From: DaSilva, Luis [REDACTED]
Sent: 26 April 2019 14:48
To: Planning.Responses
Subject: planning application consultation. - WA/20/19/HH

Your Ref
WA/20/19/HH
Our Ref
PLAN-027463
Date
26/04/2019

Proposal: Extend existing garage, front and rear with first floor extension over new front porch & canopy.
Site: 11 Orchard Way, Fontwell, BN18 0SH.
WA/20/19/HH

Due to surface water inundation issues in the Lidsey Catchment "The applicant is advised to adopt, where appropriate, the measures in the table "Practical measures to reduce the potential impacts of development".

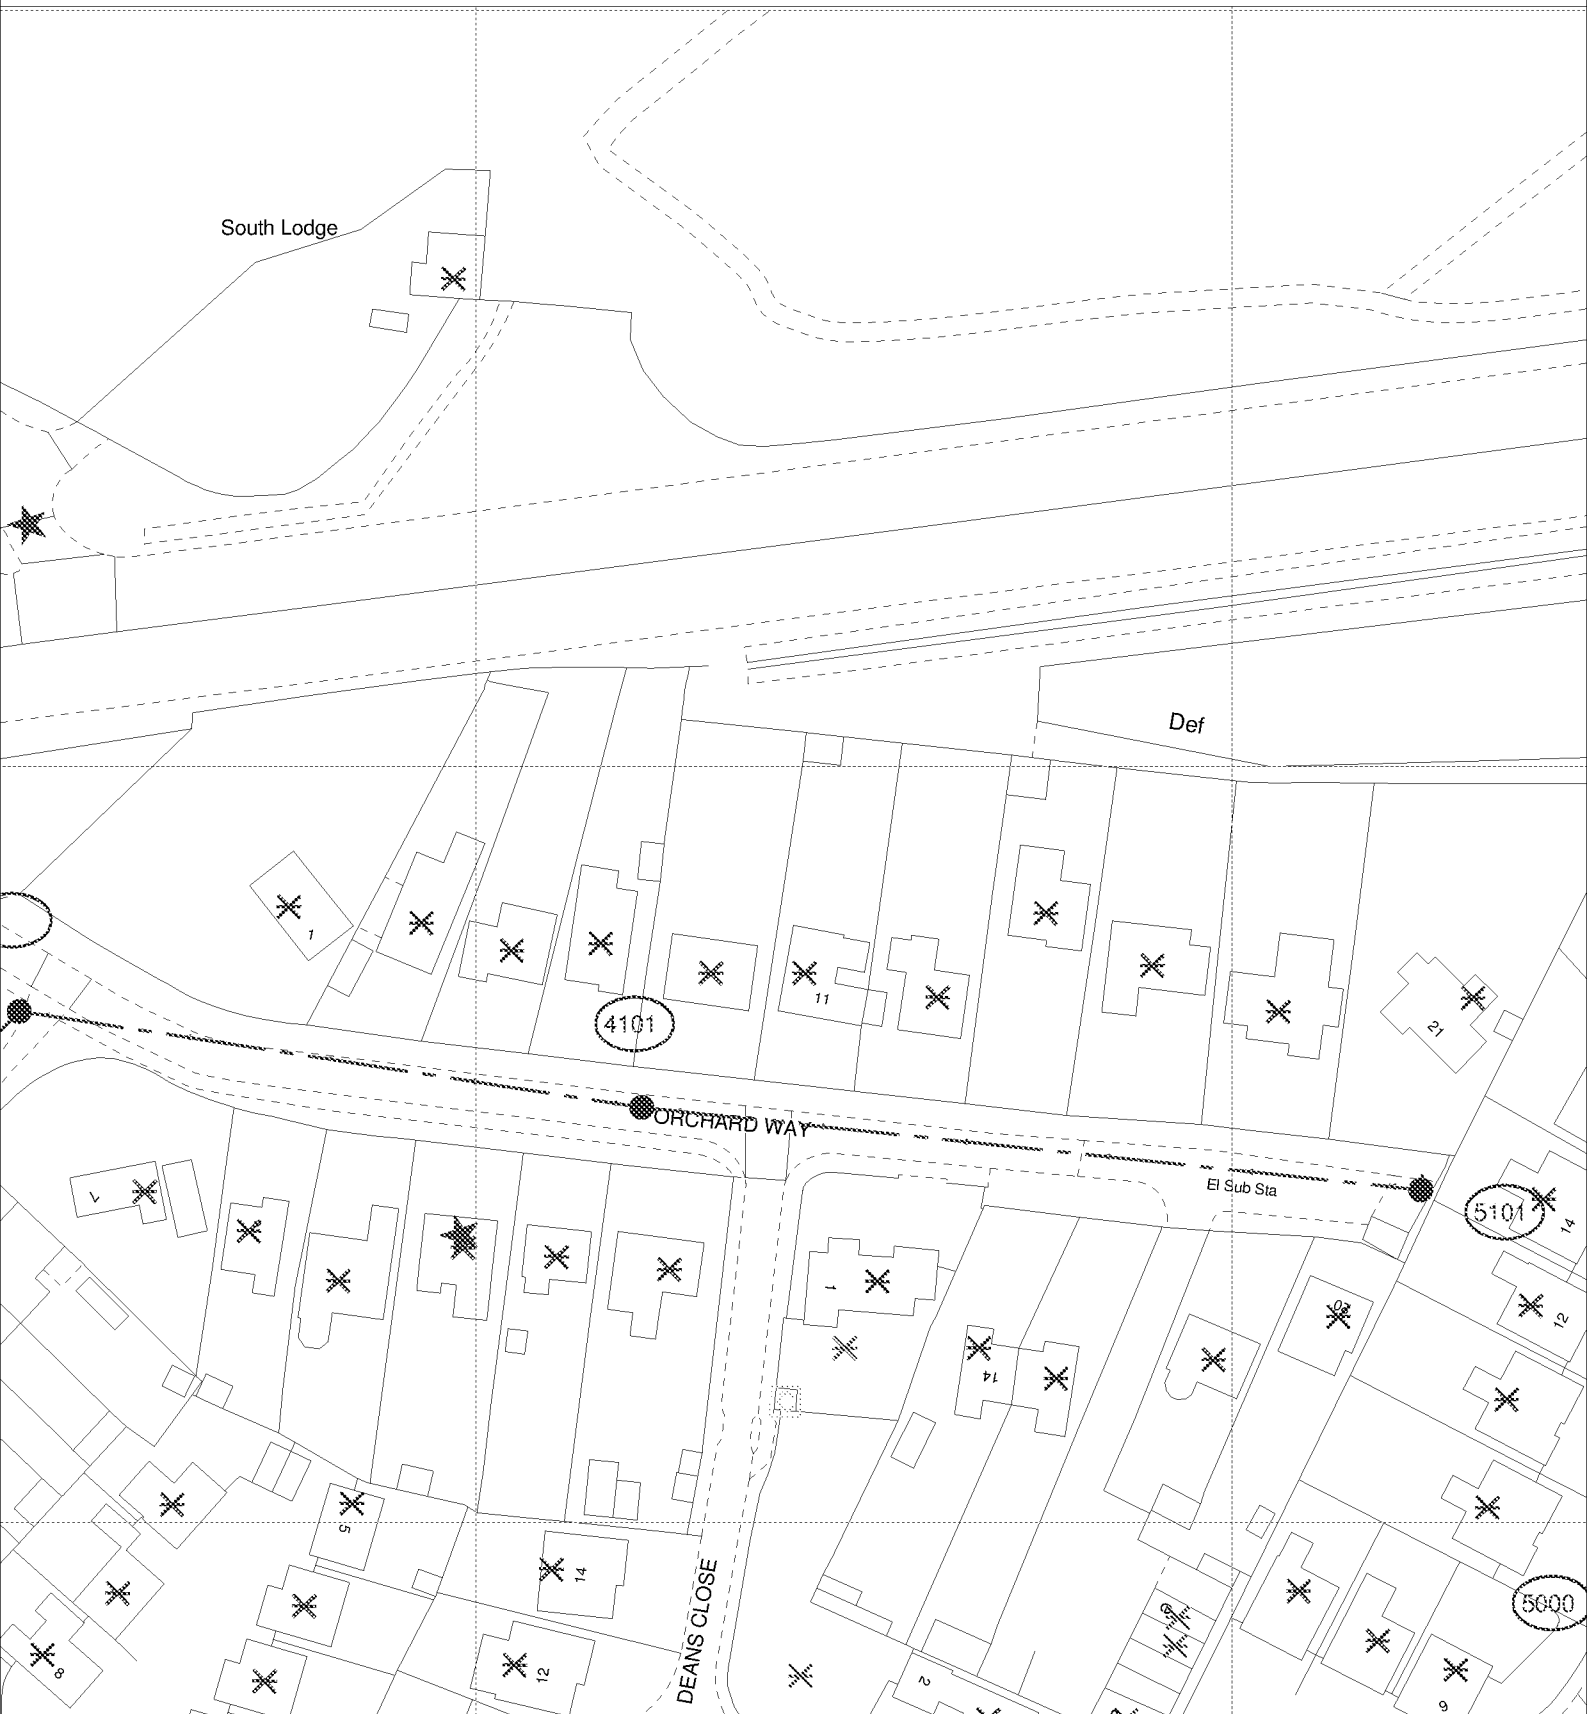
Developer should look to protect the public sewerage system from inundation and infiltration, which contribute to flooding in unfavourable conditions.
